## 2 PROJECT DESCRIPTION

This section of the Environmental Impact Report (EIR) describes SDG&E's Sycamore-Peñasquitos 230-kV Transmission Line Project (Proposed Project) in detail.

2: Project Description  
Administrative Draft Environmental Impact Report

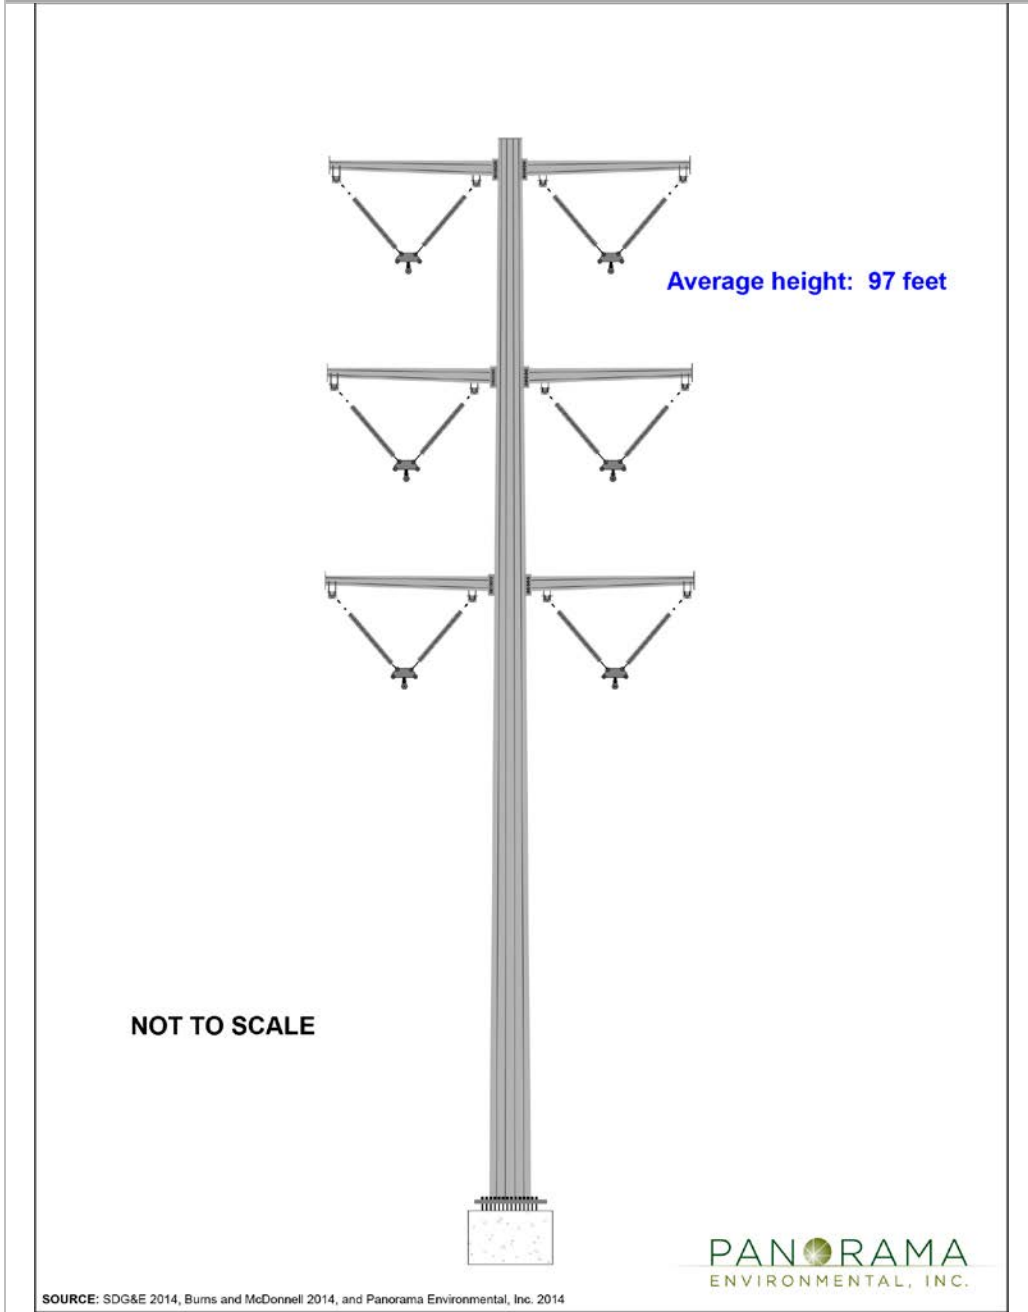
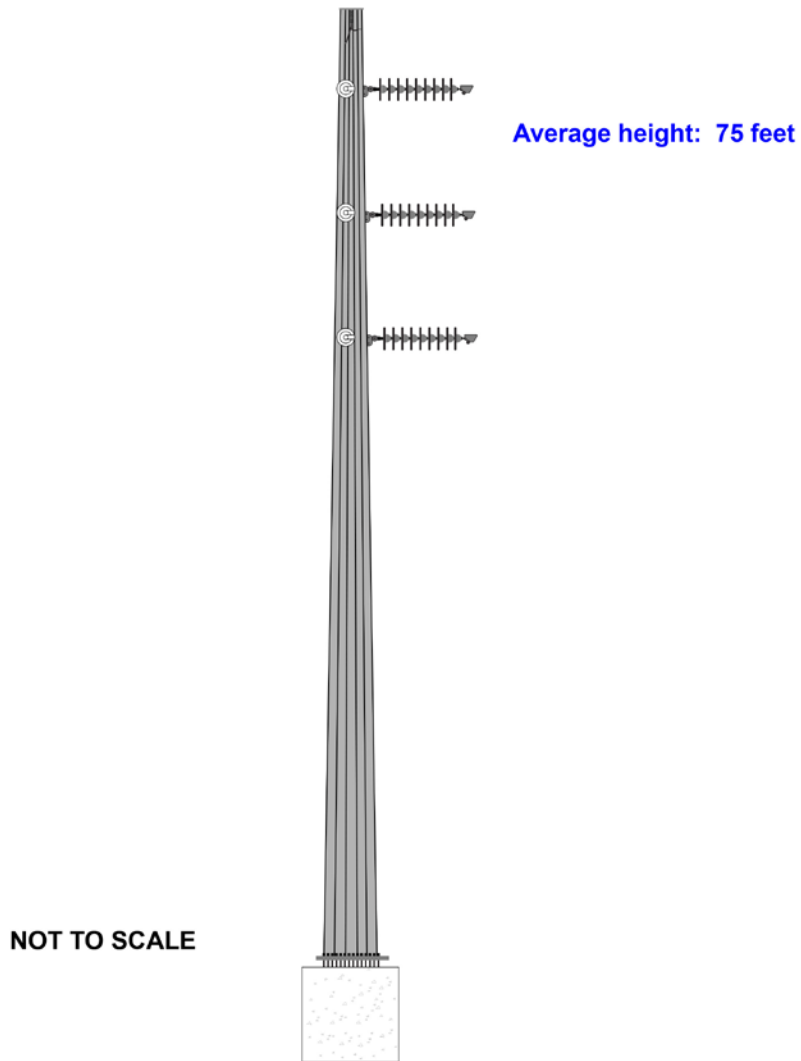
**Comment [sh1]:** Data Need: Provide typical detail for a 138-kV H-Frame structure similar to the diagrams provided in 2.3-1 below.

**Comment [TJD2]:** 138kV steel H-frame typical drawings has been provided as Attachment ED07 – Q1.

Figure 2.3-6a: Segment A Existing and Proposed Configuration

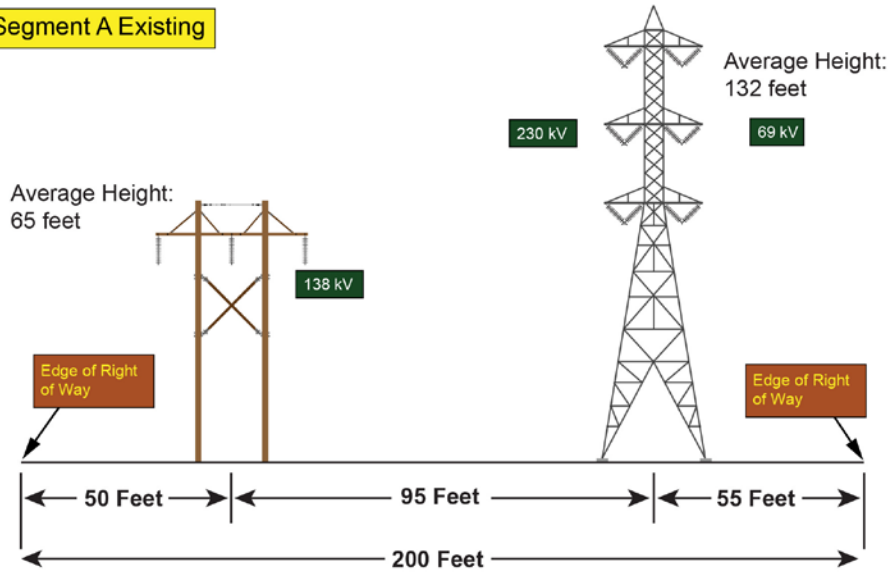
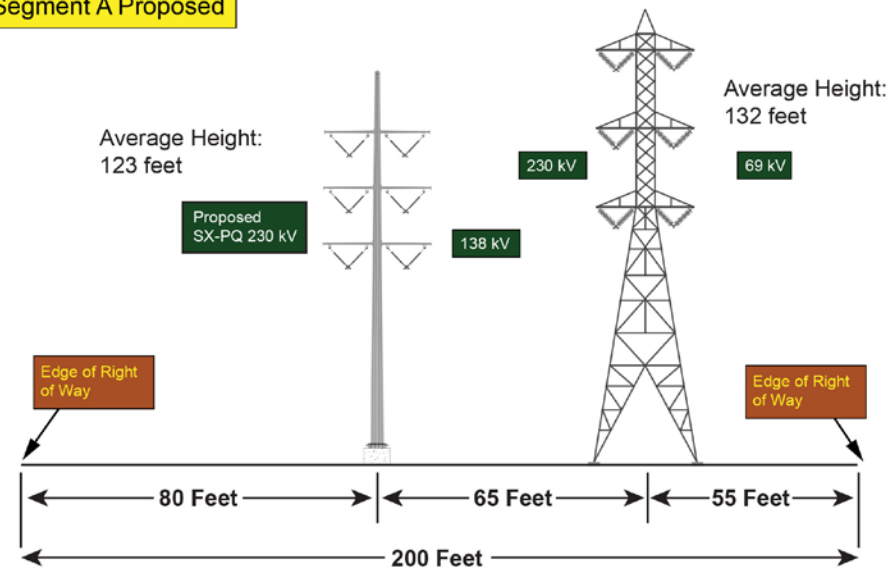
**Comment [JDT4]:** Please update figure 2.3-6a such that the average height of existing H-frame is 67 feet and the average height of the steel lattice tower is 118.

Figure 2.3-6b: Segment A Existing and Proposed Configuration

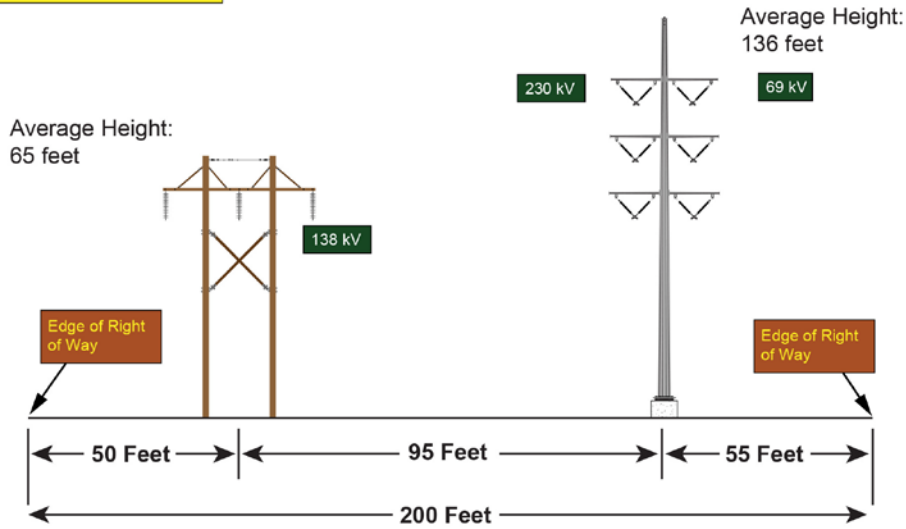
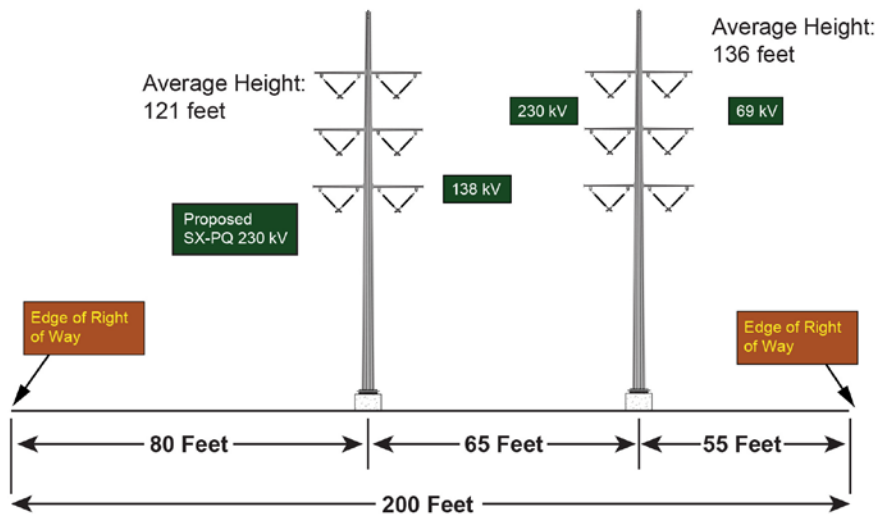
Comment [JDT5]: Please update Figure 2.3-6b such that the average height of existing H-frame is 67 feet, the average height of the existing 230kV TSP is 135 feet, and the average height of the new 230kV TSP is 123 feet.

Figure 2.3-7: Typical Topped H-Frame Structure

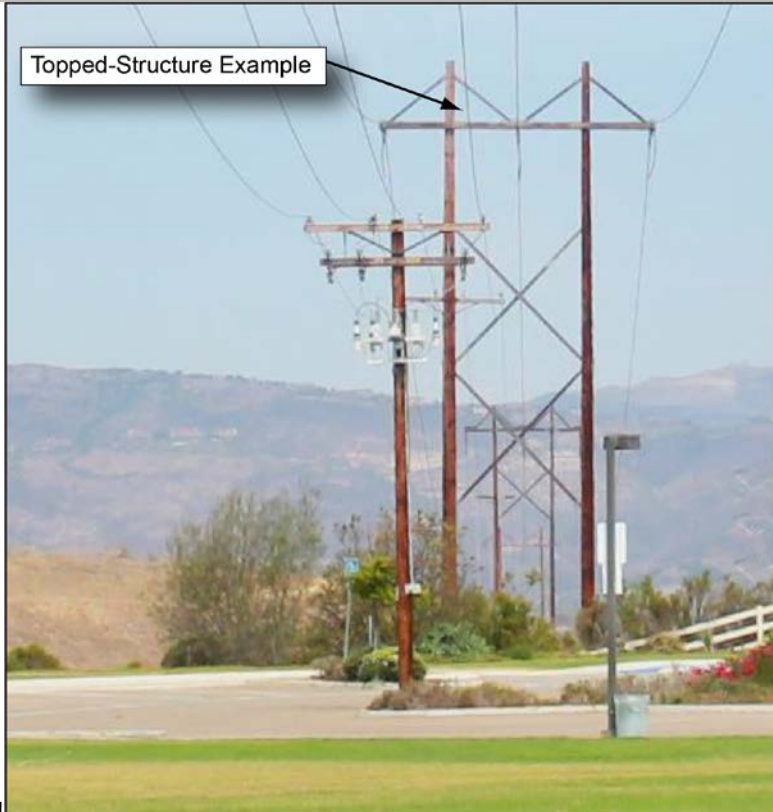
**Comment [sh7]:** Data Need: Is this the same H-Frame that is described as "replaced" above? Or is this a different structure?

**Comment [TJD8]:** Have arrow point to smaller structure in the foreground. The larger H-frame structure in the background is a representative "before", and the smaller structure in the foreground is the representative "after" the topping process.

**Comment [TJD6]:** Different structure. The steel H-frame that is being replaced is R44 (being replaced with P41A). This structure referenced here is Structure T4, and which is considered a "topped" structures where only the existing distribution line is being kept.

Figure 2.3-10: Segment D Existing and Proposed Configuration:

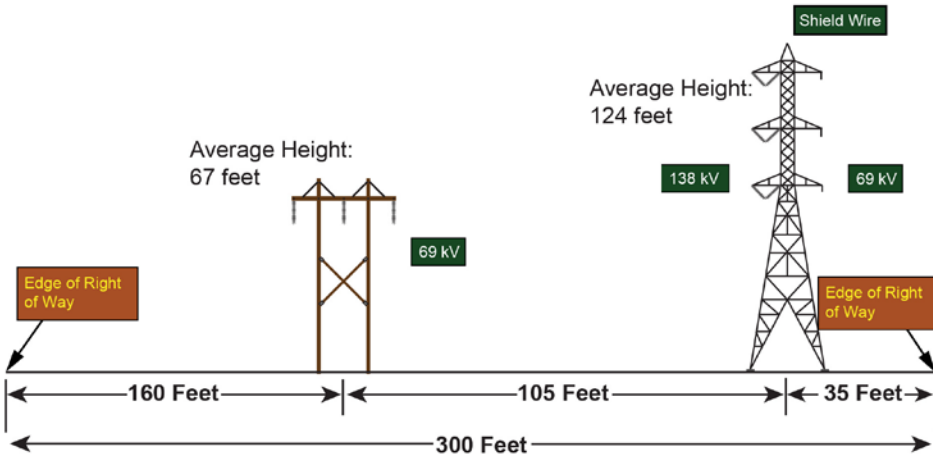
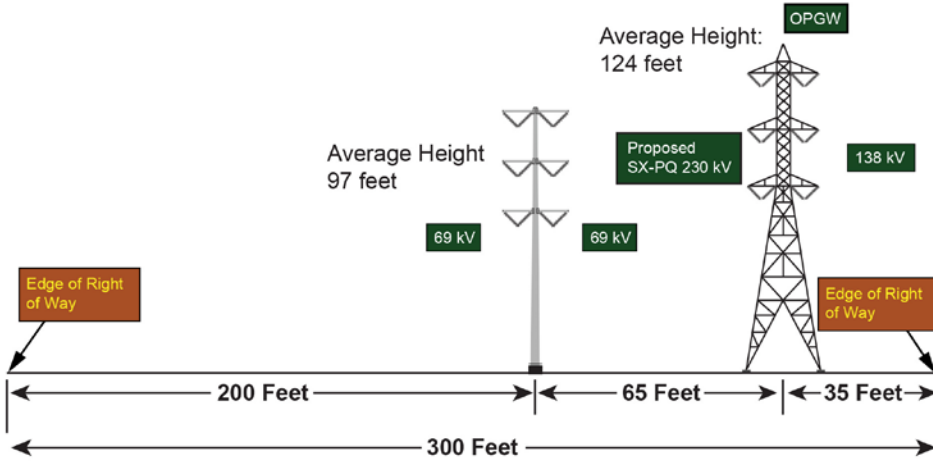
Comment [JDT9]: Please update figure 2.3-10 such that the average height of existing H-frame is 70.3 feet.

Figure 2.4-1: Staging Yards for Proposed Project

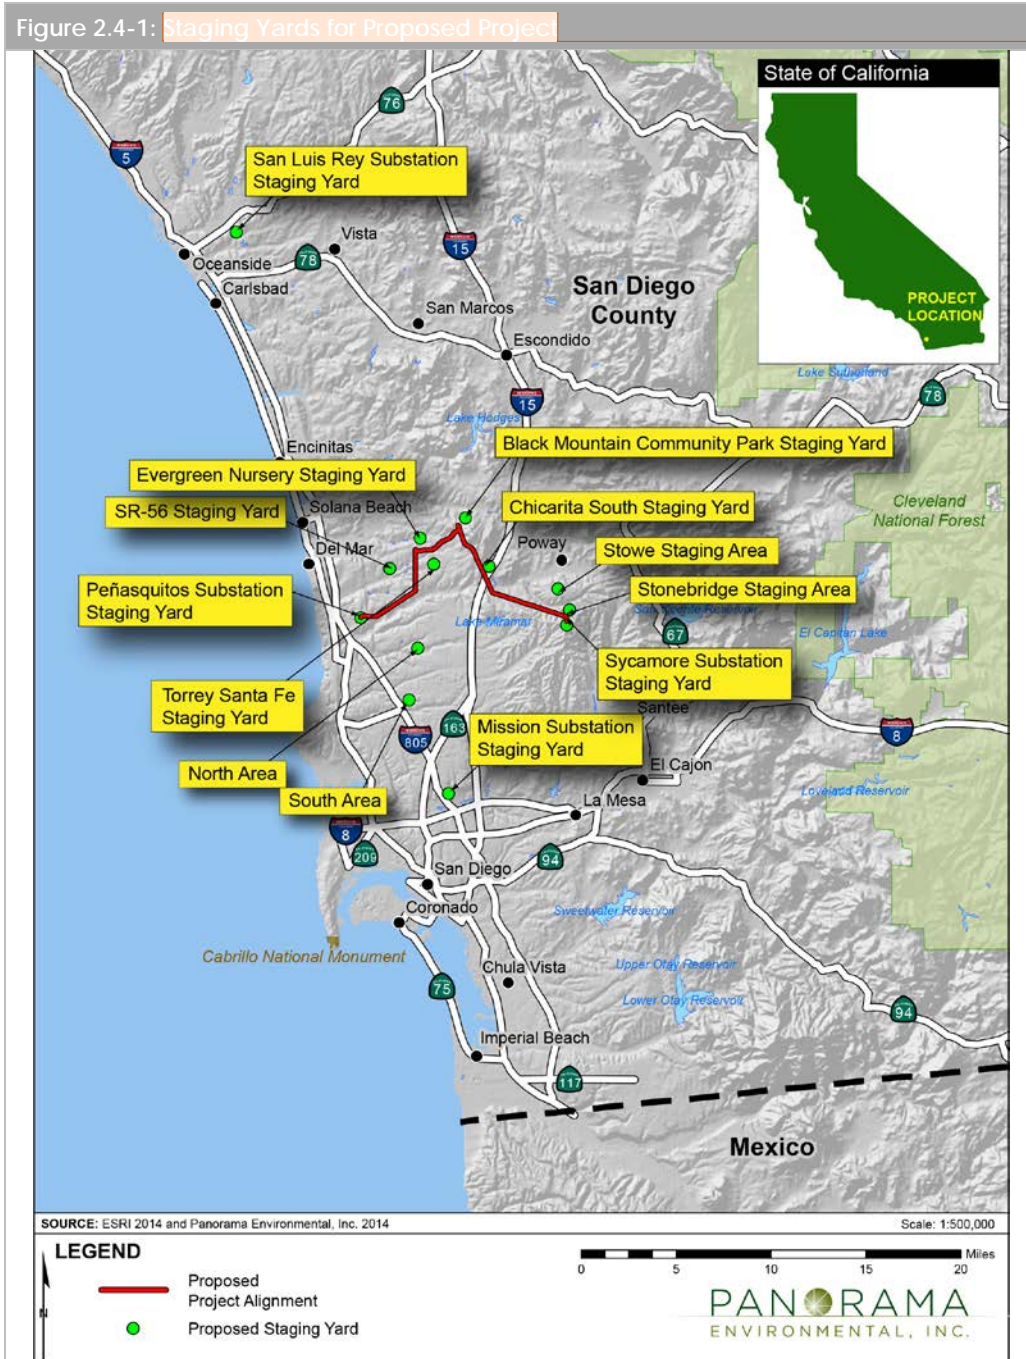
**Comment [CD12]:** SDG&E recommends that "Staging Yards" be broken into two categories: 1) Staging Yards and 2) Storage at Existing Substations to reflect the difference between a staging yard and the use of available space within an existing substation for storage. Table note #5 has been expanded to indicate the existing developed nature of the substations. Similarly, consider adding this distinction should be reflected on the maps (Figures 2.1-2, 2.3 5a & 5b and 2.4-1)

**Comment [CD18]:** Per previous comment, SDG&E recommends distinguishing storage at existing substations from "staging yards" based on the difference in their character and function.

**Comment [CD19]:** Again, SDG&E recommends distinguishing storage at existing substations from "staging yards" based on the difference in their character and function.
